RS705-4

April 18, 1980

RE: Proposed Regulatory Guide: -
"Lightning Protection for
Nuclear Power Plants"

Fig. 1.20. Discharge Currents Measured Through Lightning Arresters in Stations.

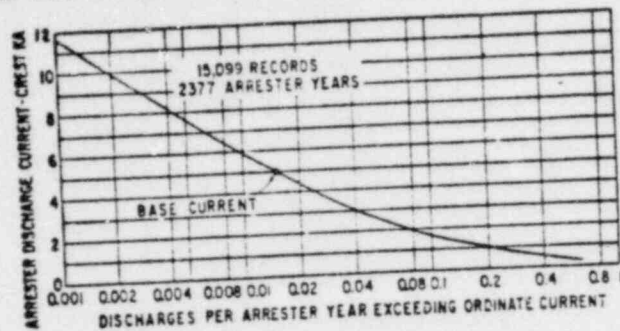
These are lower than open rural lines because the station and overhead line for at least $\frac{1}{2}$ mile from the station are generally protected by overhead ground wires. In this manner the surge will originate as a traveling wave such that the arrester discharge current will be limited by the surge impedance of the line acting in series with the arrester valve element and by the possible multiple paths encountered in the station. It is to be recognized, however, that as transmission voltages increase, the magnitude of the arrester currents in stations or on the line side of circuit breakers may increase due to the higher traveling wave voltages which can be supported by the line insulation and by the lower surge impedance of the line due to conductor bundling.

Accordingly for effectively shielded stations at 362, 550 and 800 KV, arrester discharge currents for the purpose of insulation design and coordination are increasingly greater with higher system voltages.³⁷ These arrester discharge currents are 10,000, 15,000 and 20,000 amperes at line voltages of 362, 550 and 800 KV respectively.
